MACKENZIE HIGHWAY, N.W.T., MILE 448.0 TO MILE 490.0
FINAL DESIGN SUBMISSION AMENDED OCTOBER, 1974

ERRATUM SHEET

FINAL DESIGN SUBMISSION - MACKENZIE HIGHWAY
MILE 448.0 - 490.0 - AMENDED OCTOBER, 1974

Figure 2

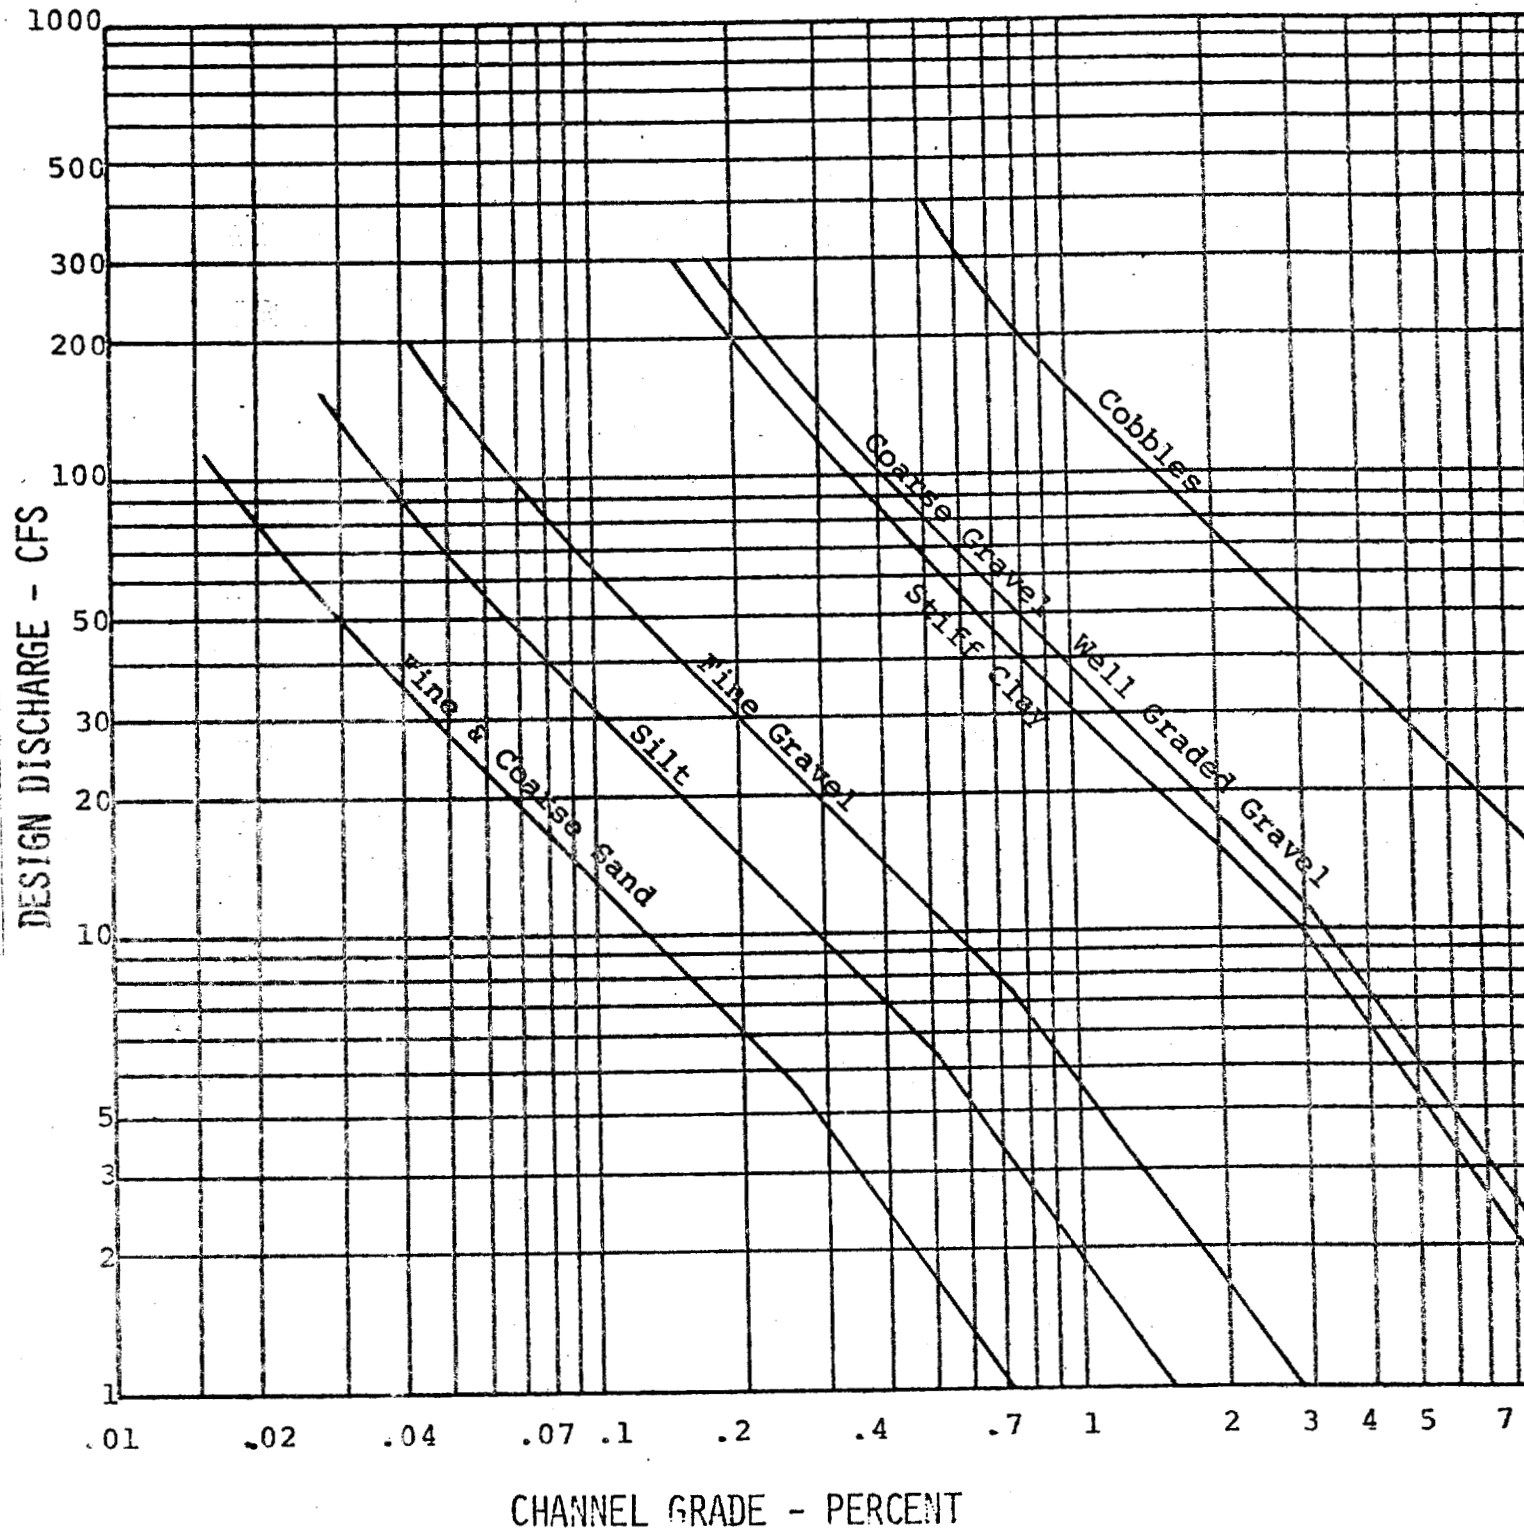
Using the limiting velocities as tabulated above and Manning's formula, discharge versus gradient curves were calculated for a twelve foot wide "B" type road ditch. (See figure 2).

For a given soil type a curve in Figure 2 indicates the limiting discharge for a given gradient above which scour erosion may occur. Therefore, theoretically, by lining the ditch with an adequate depth of material selected higher in the graph scour erosion should be arrested or minimized.

DITCH CHECKS

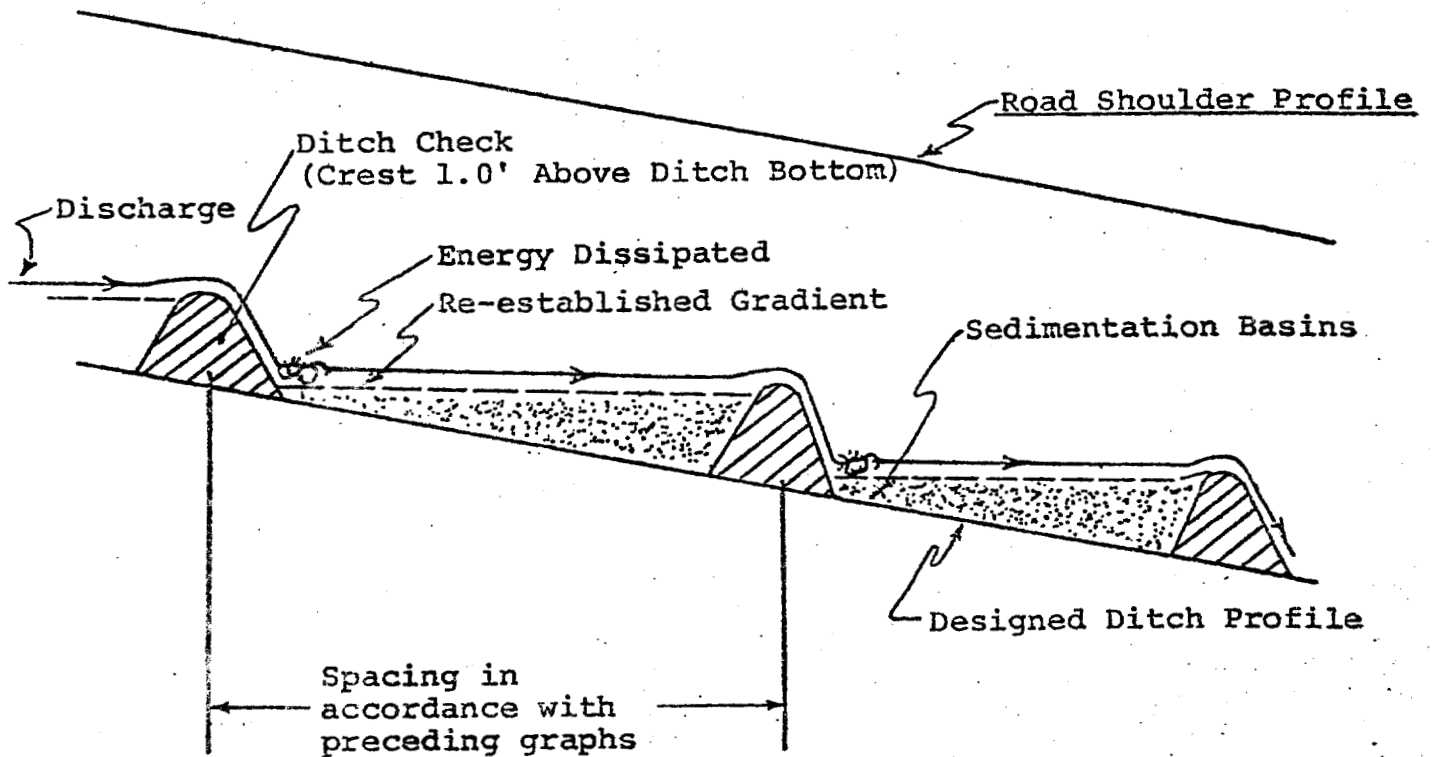
See Figure 7 of this report for a schematic explanation of ditch check theory.

- The ditch checks will be constructed with non-erodible materials.
